D. Lot 4, Lafayette Crossings / Site and Architecture / Christian Brothers Automotive

STAFF REPORT

Subject: Site and Architectural Review / Lot 4 Lafayette Crossing PUD Subdivision / Christian Brothers Automotive

SITE PLAN

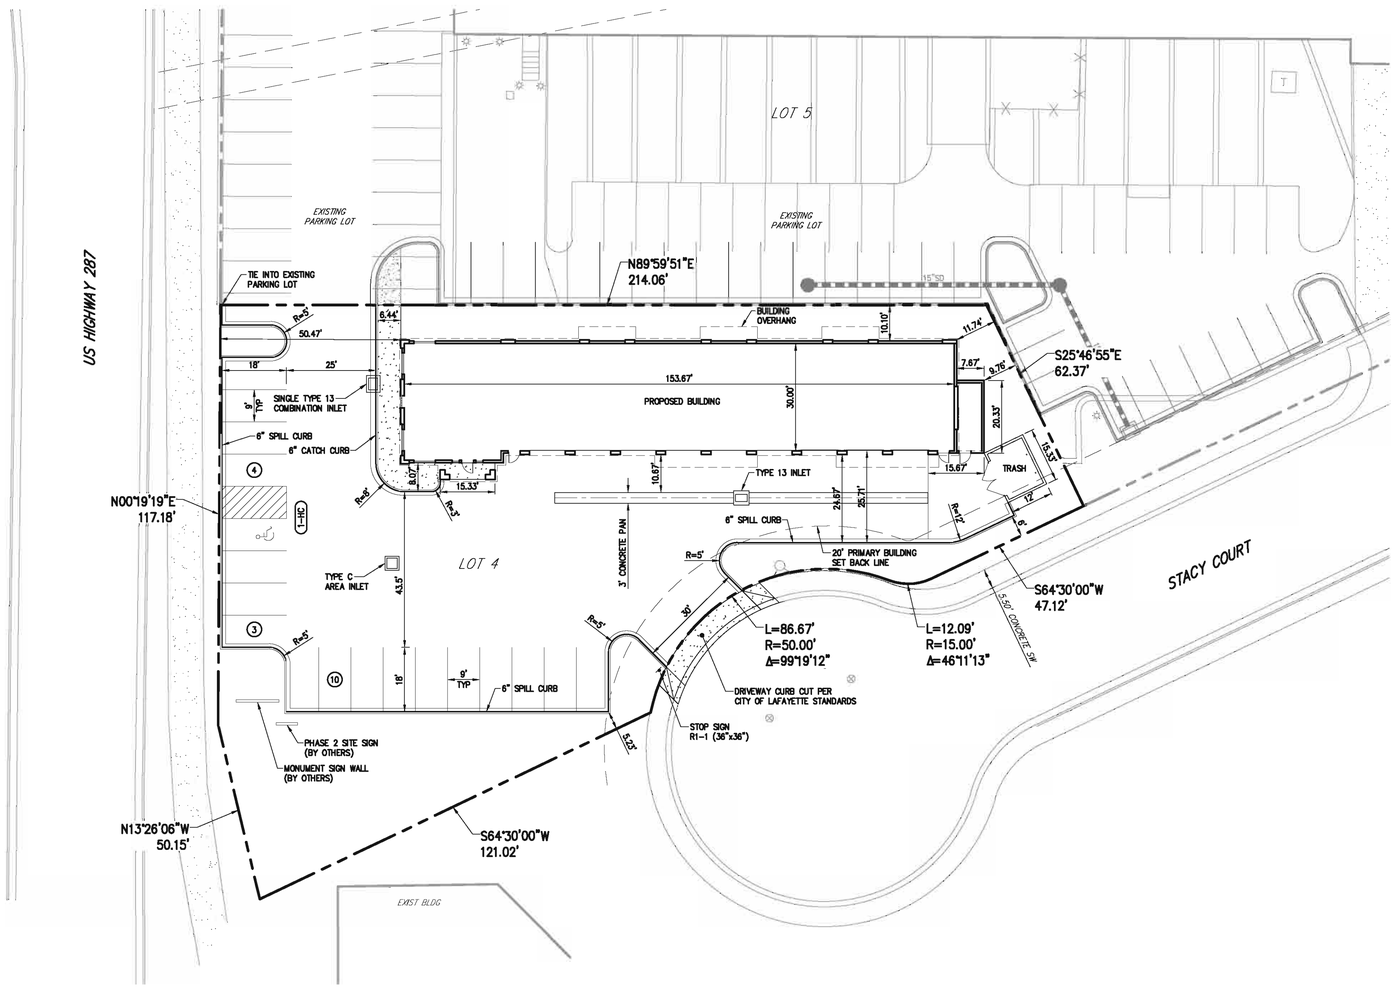
Overall, the site and architectural plans comply with the Urban Renewal Plan. The materials are high quality, the colors are compatible, and architectural articulations include the various columns and extended roof lines. However, it is staff's opinion that the right side (east) elevation should include the split face reddish brown concrete masonry units rather than the ground face grey masonry units. The split face units will add slightly more articulation to this wall, and will more closely match the left side (west) elevation of the automotive bay area. In addition, it is staff's opinion that a pedestrian/bicycle connection should be provided from the site to the Highway 287 sidewalk/bicycle path and that the site should include a bike rack.

1. Subject to approval by CDOT, a pedestrian/bicycle connection shall be added in the southwest corner of the site connecting to the Highway 287 sidewalk/bicycle path.
2. A bike rack shall be included on site.
3. The ground face gray concrete masonry unit proposed on the right side (east) elevation shall be changed to the split face reddish brown concrete masonry unit.
